# PLANNING & DEVELOPMENT COMMITTEE

**Address:** 316, 318, and 320 *West Main Street*

Proposal: Preliminary site plans for removal of existing buildings, combining three parcels into one, and construction of a drive-in restaurant

**“Sketch Plan Review”**

# 2000 INSPIRE PROTOTYPE SITE LAYOUT #1

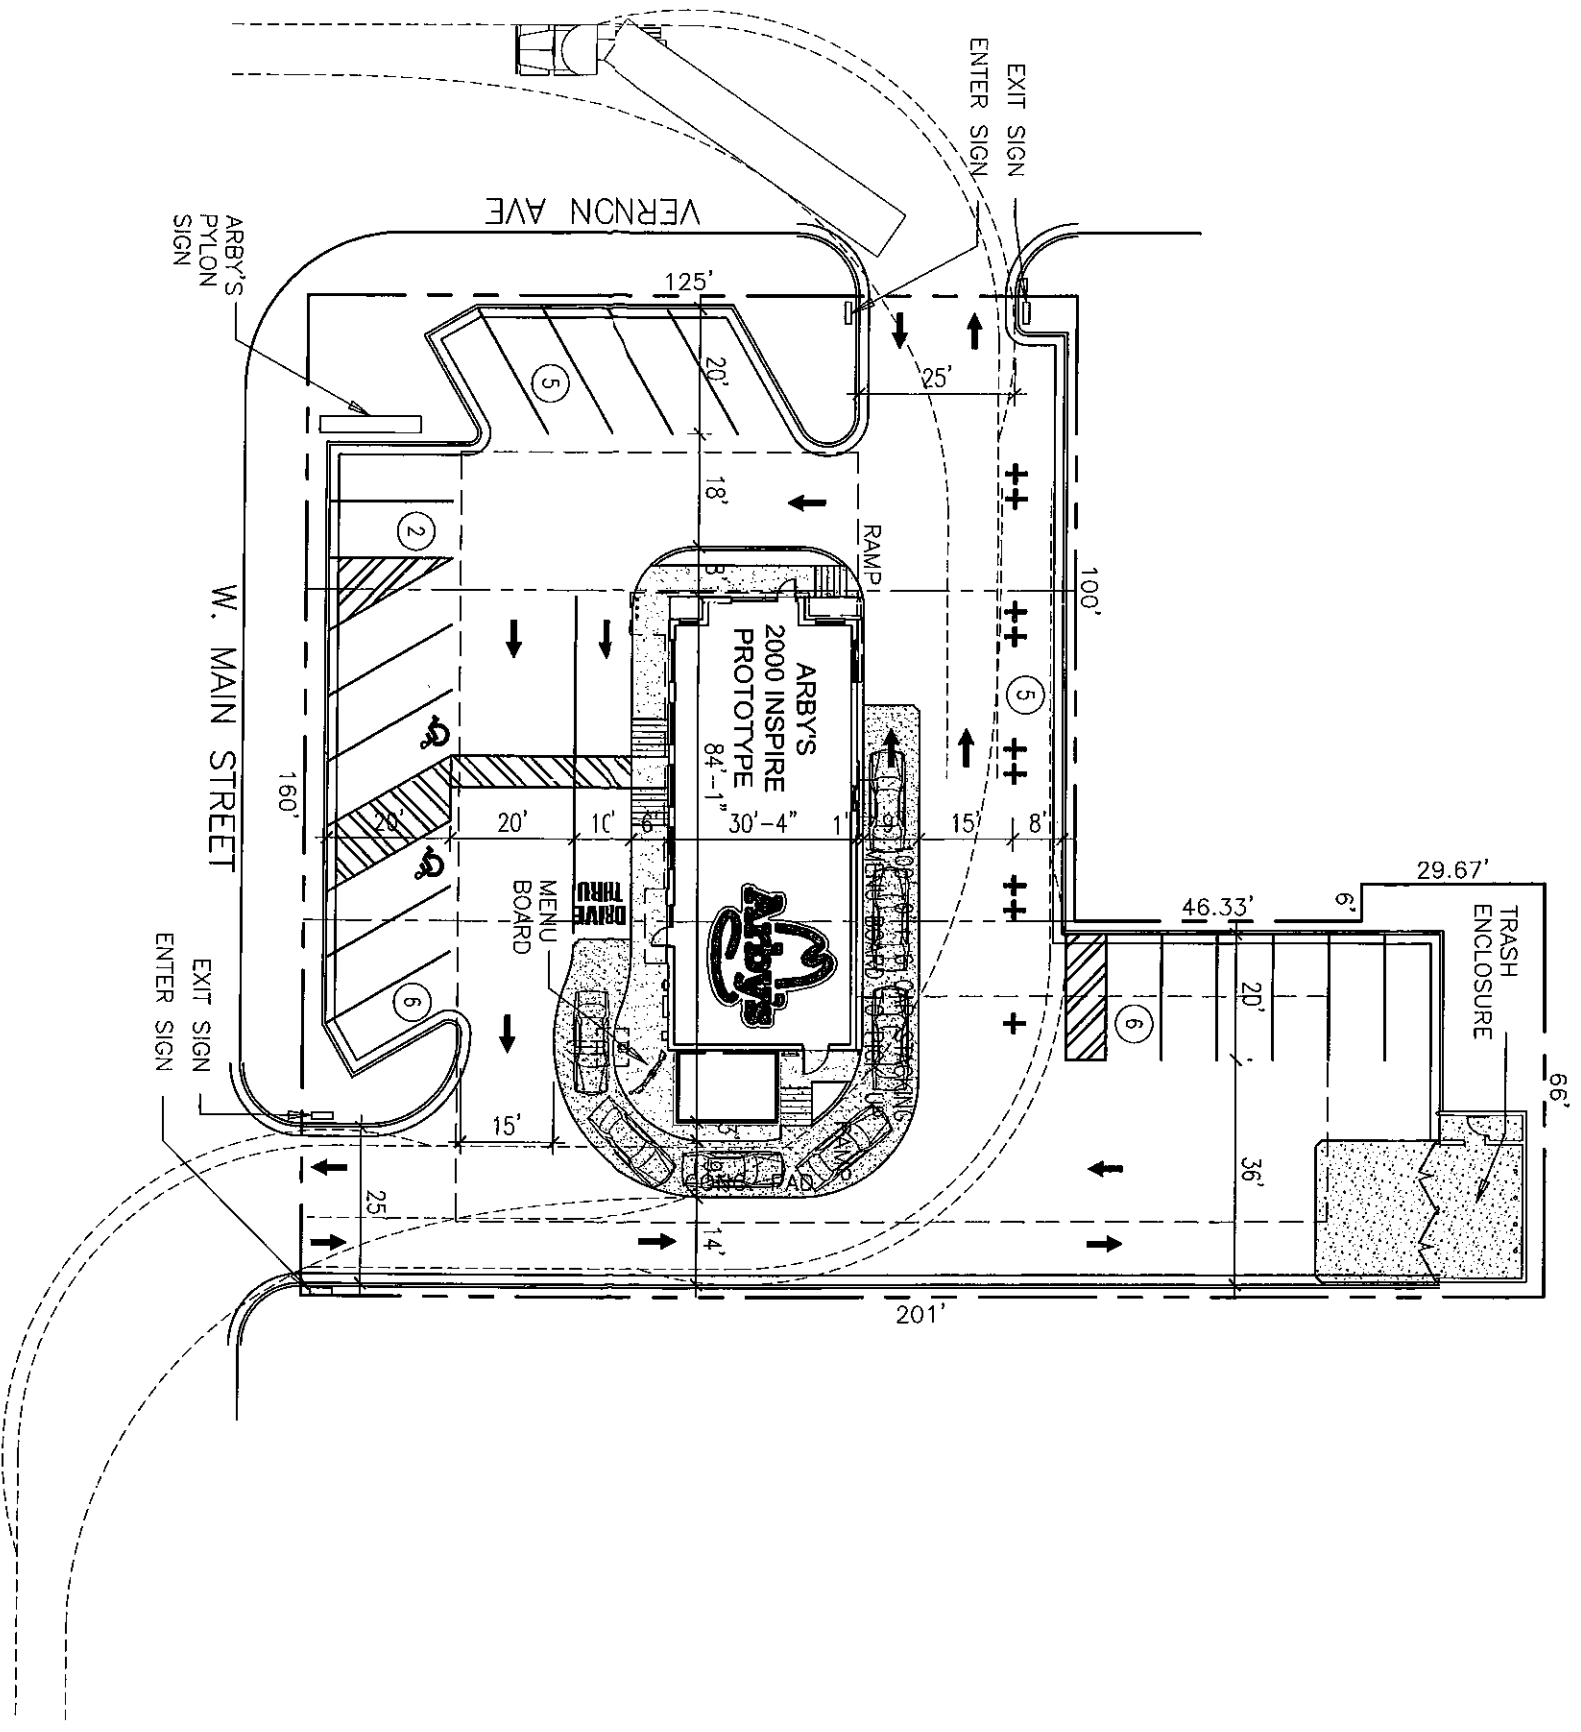
- Special Use Permit required for Drive-in restaurant.
- 84 Parking spaces are required for a 2,100 sq.' drive-in restaurant (4 spaces per each 100 sq.' of floor area)
- Driveway width to be no less than 20' and no more than 24' at any point.
- Driveways to be no less than 20' from side lot lines.
- Public garages and places of public assembly (restaurant) are not to be closer than 500' apart.
- Fences, hedges, etc. screening at residential properties.
- 10' Landscape buffers required between parking spaces and front property lines.
- 10' Landscaping buffer between commercial and residential properties.
- Compliance with landscaping for site.
- Parcel merger required prior to permit issuance.
- 18' maximum height

An area variance (ZBA) would be required for any of the above items that could not be complied with.
